Updates to Wisconsin's Landfill Design and Operations Administrative Code

The Wisconsin Department of Natural Resources (DNR) has updated regulations in chapters NR 500 – 530, Wis. Adm. Code, affecting municipal solid waste (MSW) and industrial landfills. Many of these changes are designed to create consistency or provide additional clarity. Most of these changes take effect Oct. 1, 2025. The DNR will work with affected facilities on implementing the code revisions, and will share more details soon regarding specific requirements and implementation timelines.

Figure1: Alternative composite landfill liner design

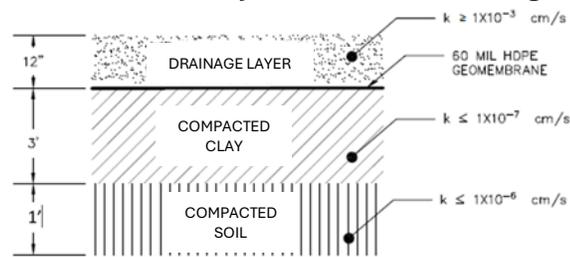
- An optional landfill liner design that uses 3 feet of clay soils and 1 foot of compacted soils instead of 4 feet of clay soils (see Figure 1).

- 1 foot of prepared sub-base under all portions of the clay liner
 - 3 feet of clay at the base of the liner
 - 4 feet of clay under the leachate collection sump
 - 2 feet of clay for the 3:1 side slopes
- Alternative landfill cover designs to be proposed as long as they meet performance criteria and adequately protect public health, welfare and the environment.
 - Intermediate waste grades are permitted up to 10% of the depth of waste in a location. Requests for 5% - 10% intermediate waste grades are required to establish owner financial responsibility for removal of wastes that do not settle.
